**NOTICE OF MEETING
PLANNING & ZONING COMMISSION
TUESDAY, MAY 5, 2026
T.W. "TURK" CANNADY – CEDAR HILL ROOM
CEDAR HILL GOVERNMENT CENTER
285 UPTOWN BLVD. – BLDG. 100
CEDAR HILL, TEXAS 75104
6:00 P.M.**

RE: Case No. FP-781-2026 (Final Plat – Milotte Margaret Estates, Lots 2R, 3R-1, and 3R-2, Block 1)

SEE SHEET 2

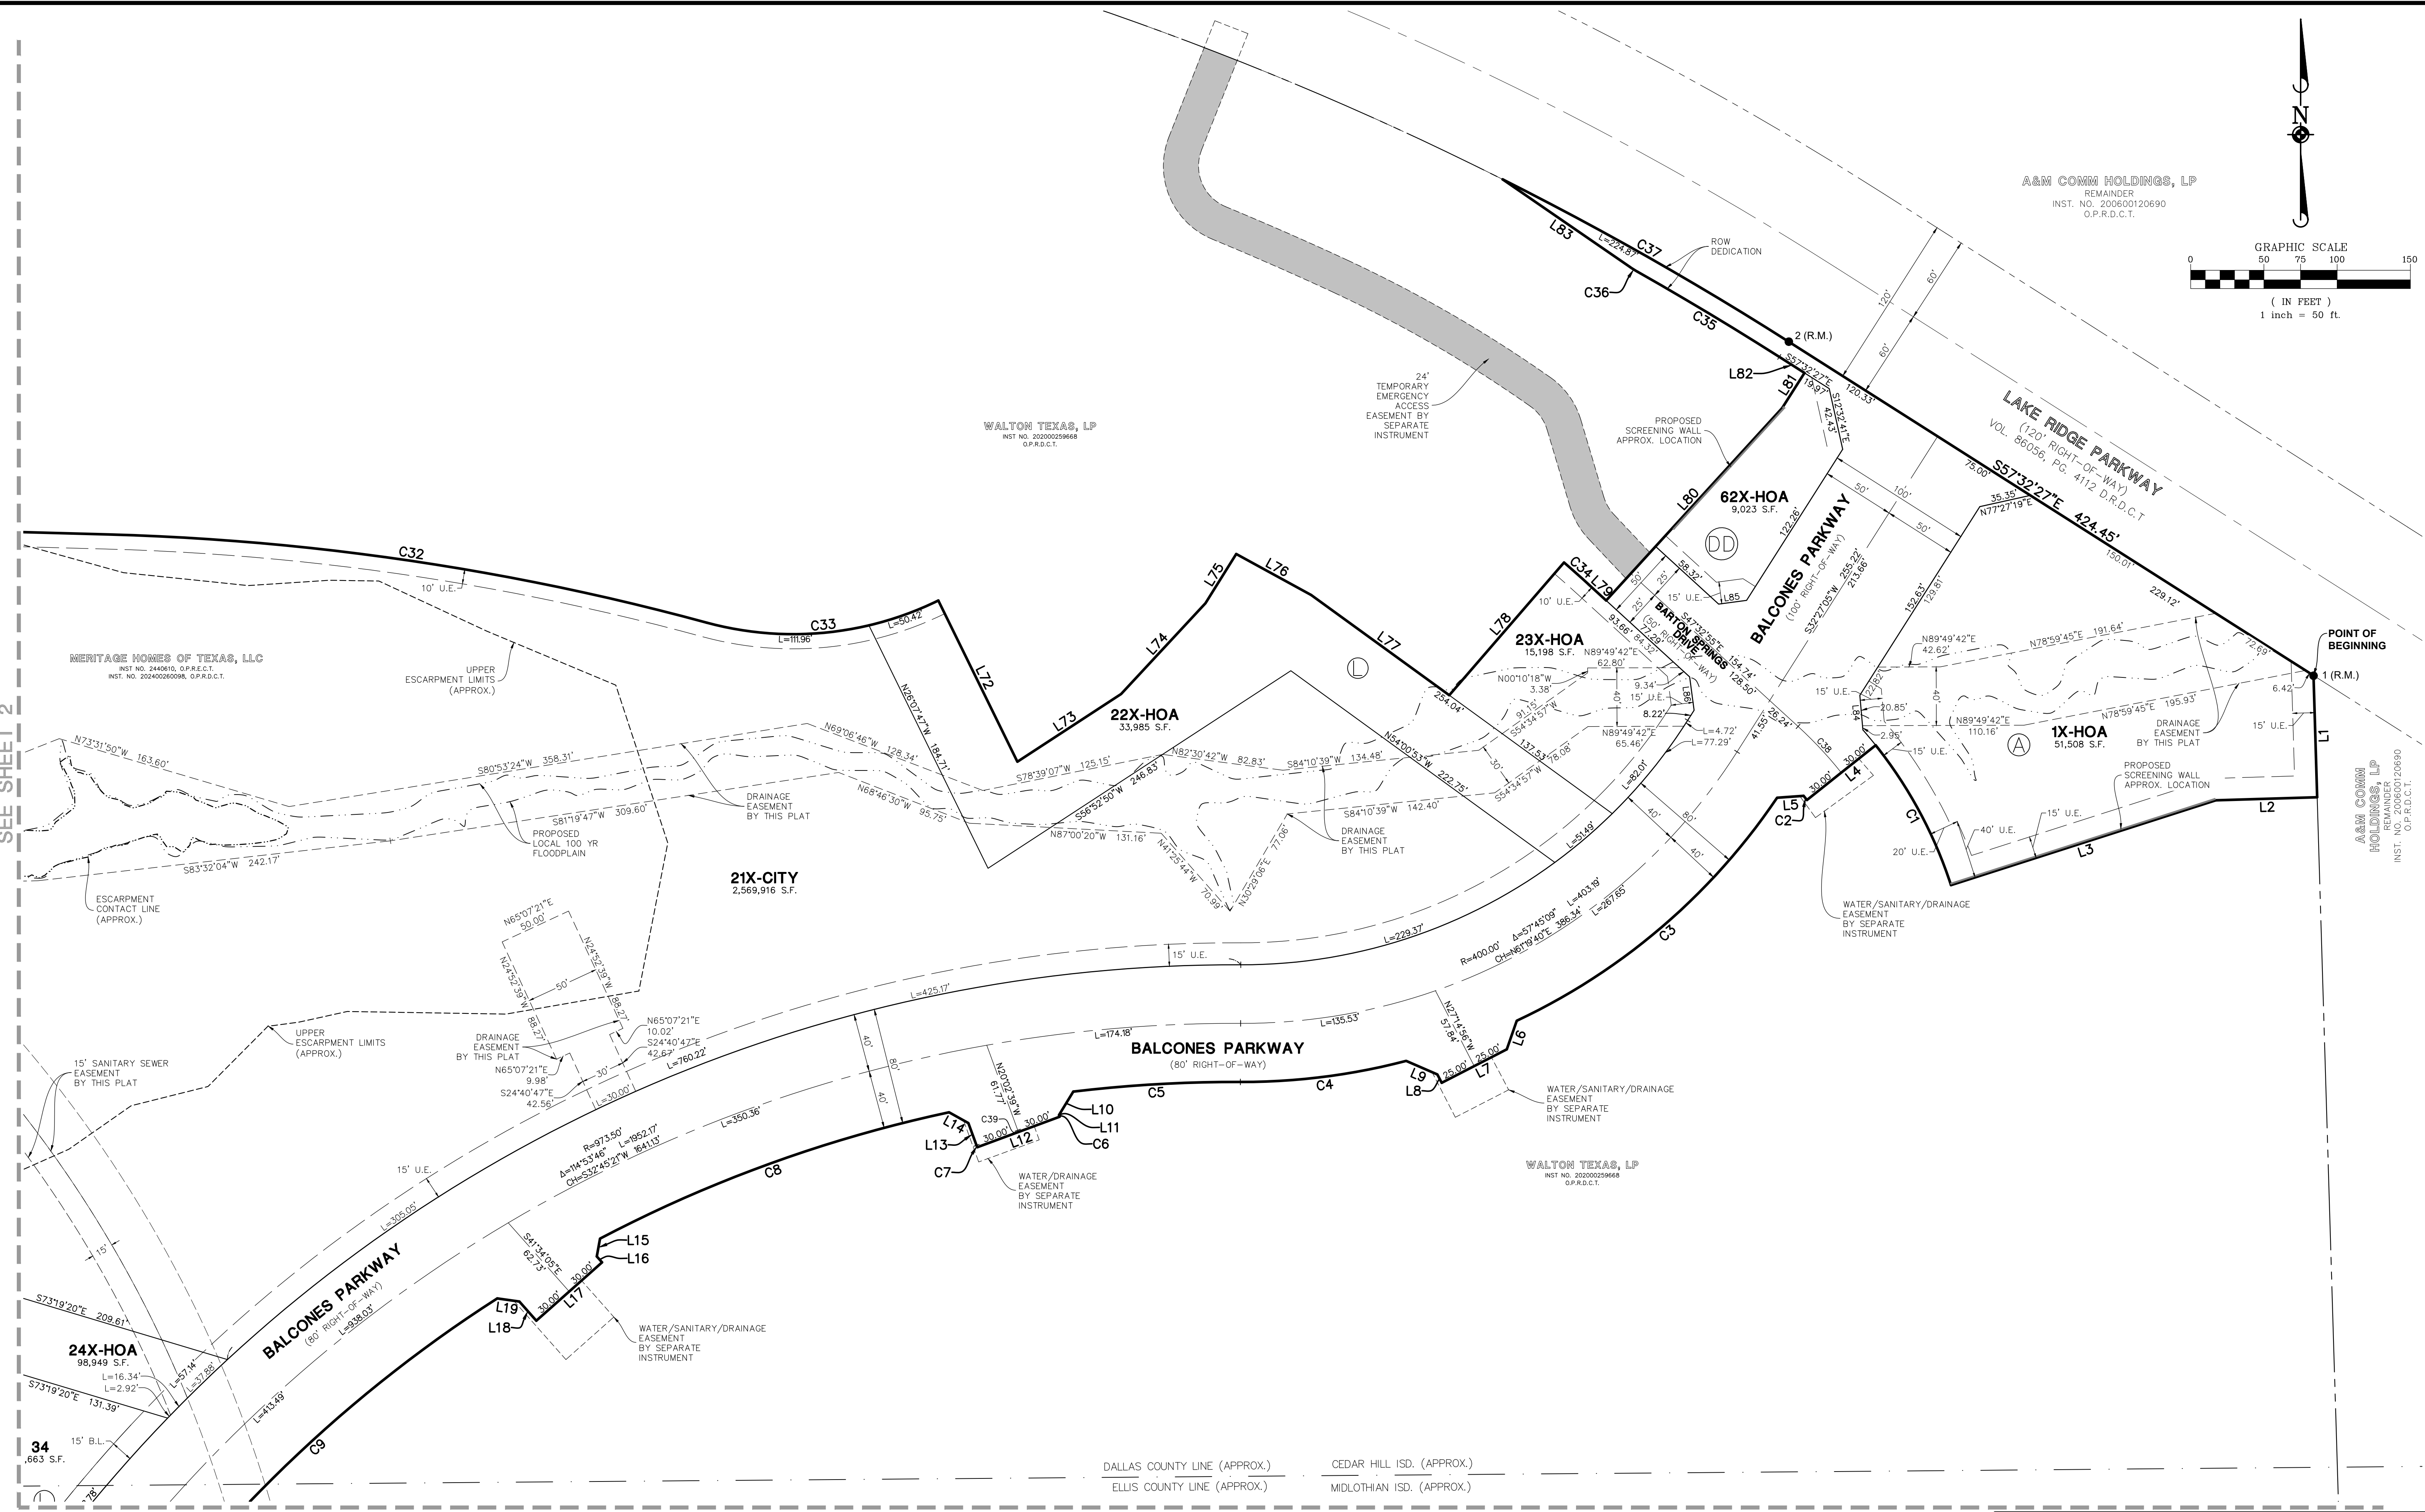
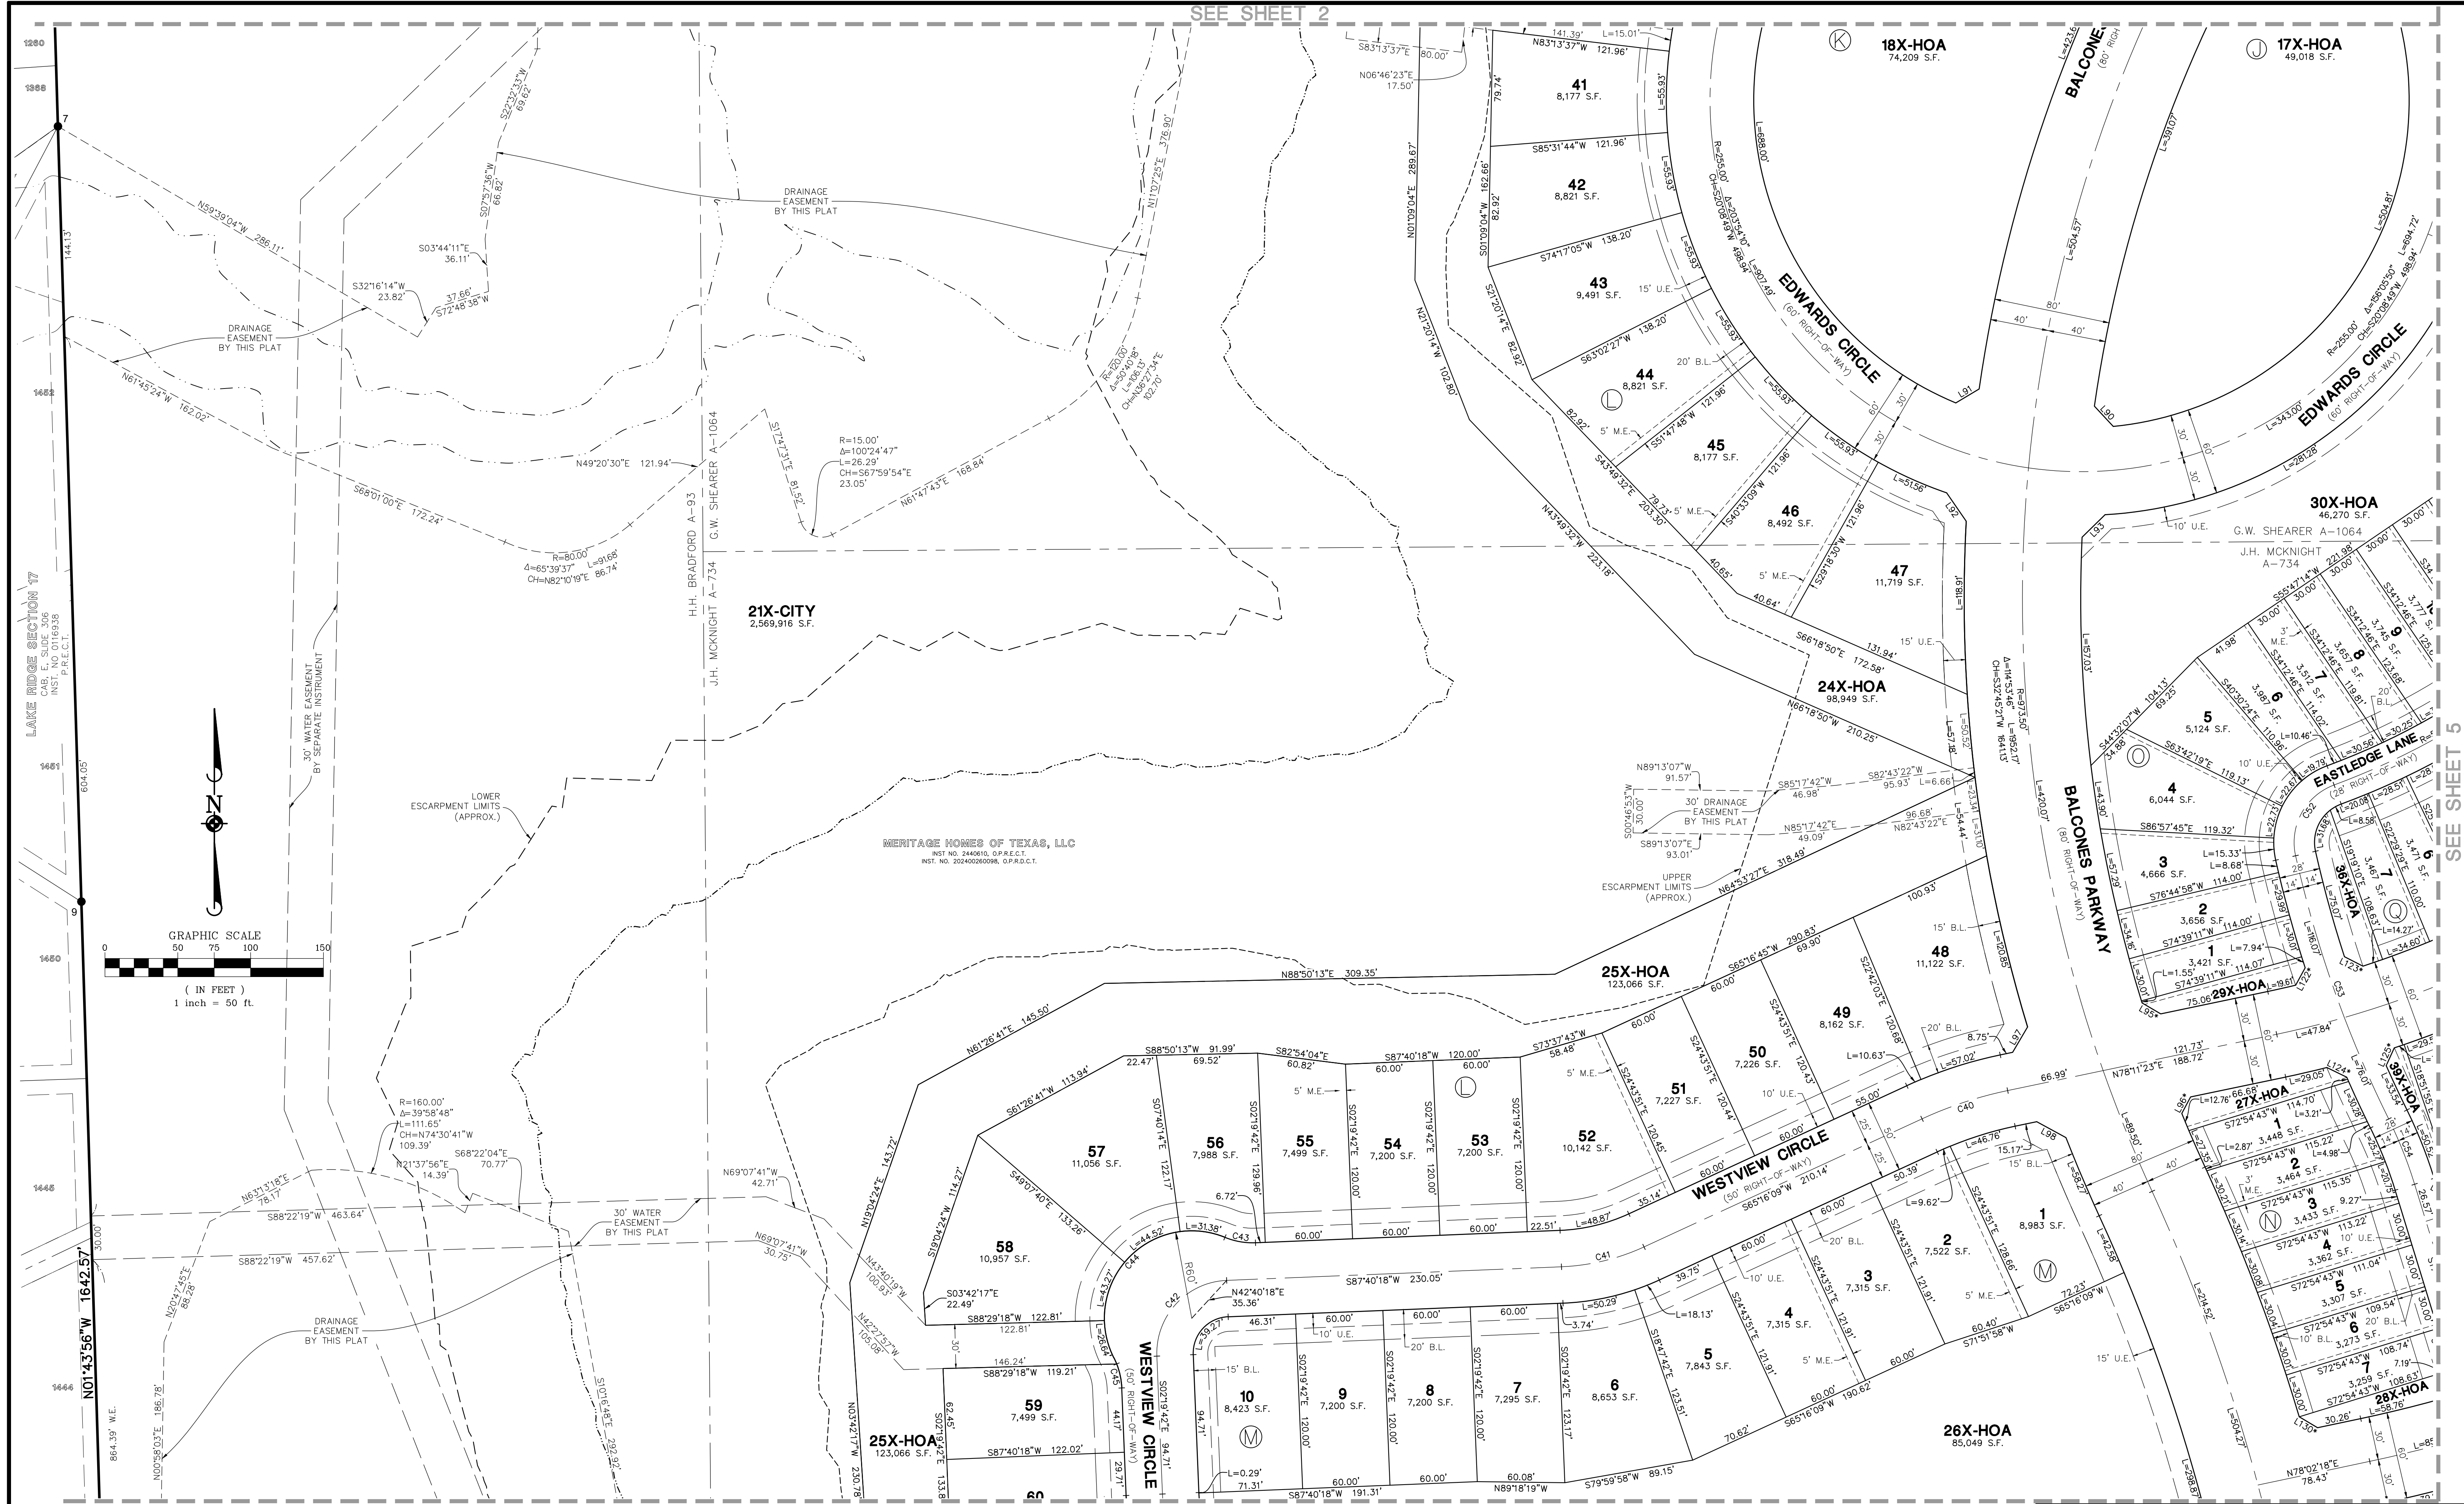
Planning Department	Code Citation
<p>1. Provide evidence of plat distribution to the applicable franchise utility companies.</p> <p>Simply send them an email to the applicable contacts, and copy the City and with the following: <i>"On behalf of the (applicant's name), we are submitting a final plat at (address) for a residential subdivision of 238 lots in Cedar Hill, Texas. If you have any questions, please contact me and/or the applicant."</i></p>	<p>Chapter 20, Section 20-11(c)(1) thru (9) of the Subdivision Regulations</p>
<p>2. Provide approval from the Post Office regarding the proposed residential subdivision layout PRIOR TO RECORDATION of the Final Plat.</p>	<p>Chapter 20, Section 20-11(c)(9) of the Subdivision Regulations</p>
<p>3. Provide a certified copy of the owner association agreement and association by-laws where required for maintenance prior to the recordation of the plat.</p>	<p>Chapter 20, Section 20-11(b)(21)(b) of the Subdivision Regulations</p>

<p>4. Add case no. FP-782-2026 underneath the Title Block.</p>	
<p>5. This property is within both Dallas County and Ellis County. Staff contacted both Counties requesting requirements for the recording of this Plat.</p> <ul style="list-style-type: none"> • Ellis County response – plat must meet both Texas Property Code for recording and TLGC. Plat sheet size must be 18"x24". • Dallas County response – plat must clearly show/delineate both Counties. Typical Plat sheet size is 24"x36", but they will accept 18"x24". <p>Contact each county directly to confirm and revise sheet layout as needed.</p>	<p>See the attached County correspondences</p>
<p>6. Provide the following note on the plat. "Selling a portion of this addition by metes and bounds is a violation of the Subdivision Regulations and State law and is subject to the withholding of utilities and building permits."</p>	<p>Chapter 20, Section 20-2 of the Subdivision Regulations and TLGC, Section</p>

212.004
7. Remove all building lines and/or yard setback lines and call outs from the proposed plat. Add the following note on the plat. "Building setbacks shall comply with the Zoning Ordinance at the time of the Building Permit."	Chapter 20, Section 20-11(b)(9) of the Subdivision Ordinance

8. Provide the bearing and distance information for all proposed easements.	Chapter 20, Section 20-11(5) of the Subdivision Ordinance
9. Label all existing and proposed easements.	Chapter 20, Section 20-11(b)(5)c of the Subdivision Ordinance

10.The table listing the residential lots and the HOA/Open Space lots has missing lot numbers. Please revise.	Chapter 20, Section 20-10.b(8) of the Subdivision Ordinance

11.Provide the recording information for all proposed off-site easements and/ or easements not by this plat, on this plat prior to the recordation of the plat.

12. Revise the Title Block to separate how many acres are in Dallas County and Ellis County. Add "Addition" to the Title Block and under "Dedication".	Chapter 20, Section 20-11(b)(11) of the Subdivision Regulations; Chapter 20, Section 20-11(f) of the Subdivision Ordinance

13.Per PD, A minimum of 10% of the total 30' / 40' / 50'/ 60 -ft lots with the property may be allowed no more than 5% reduction in area due to site constraints. Verify and confirm.	PD No. 2024-813 Section 10

14. Provide an exhibit that overlays the following information on a plat layout to confirm the maintenance easement locations on this plat: a. all the retaining walls required per engineering plans b. all the fences/screening walls required that will be owned and maintained by the HOA per Section 10.O of PD-2024-813. c. all the maintenance easements associated with walls and fences listed above.	Chapter 20, Section 20-11(b)(19)

15. Remove the telephone and email address from plat.	
16. Add "By this plat" to all proposed plats and add "Dedicated by this plat" to all city properties.	
17. Label all HOA lots on all sheets	
18. Confirm that the meets and bounds does not have to be separated per county property.	
19. Add the Title within the Meritage Homes of Texas Organization for Frank Su under the Dedication Certificate.

Parks Department	Code Citation
1. Park Land Dedication per PD Ordinance has been satisfied. The park development fee of \$700 per dwelling unit will be required. The developer is constructing a 10-foot concrete city trail that is approximately 3,300 linear feet with Phase 1 infrastructure improvements. The developer may utilize this fee requirement for the construction of this trail. Please provide a cost estimate (OPC) for the construction of this trail.	Chapter 20, Section 20-42(c) & Section 20-43(a) of the Subdivision Regulations
2. Provide 10-ft Trail Easements for the trail sections that cross HOA lots.

Public Works Department	Code Citation
1. Provide Northern and Easterlings for at least two corner pins for reference in city GIS system.	Chapter 20, Section 20-11(b)(3) of the Subdivision Regulations
2. Please remove the escarpment limits and contact line from the Plat. However, a note shall be added that the escarpment exists and that there is a plan associated. This shall comply with the City Ordinance and the escarpment plan.	Chapter 20, Section 20-75(c) of the Subdivision Regulations
3. Please indicate that City lots are being dedicated by this Plat.	
4. Please add a note stating any changes in the approved grading plans shall be submitted to the city.
